ECN/PCN No.: M1198

For Manufacturer		
Product Description: <p align="center">SMT Air Coil Inductor</p>	Abrakon Part Number / Part Series: <p align="center">AIAC-1812 Series</p>	<input type="checkbox"/> Documentation only <input checked="" type="checkbox"/> Series <input checked="" type="checkbox"/> ECN <input type="checkbox"/> Part Number(s) <input type="checkbox"/> EOL
Affected Revision: <p align="center">G</p>	New Revision: <p align="center">H</p>	Application: <input type="checkbox"/> Safety <input checked="" type="checkbox"/> Non-Safety

4.0 Part Number Identification

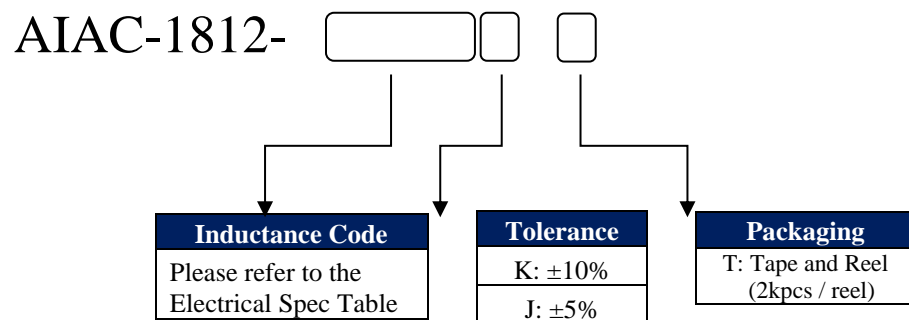
8.0 Packaging

T: 2,000pcs / reel

Qty/Reel is erroneously stated as 2000Kpcs for the series. Correct to 2Kpcs/reel.

8.0 Packaging

T: 2Kpcs / reel
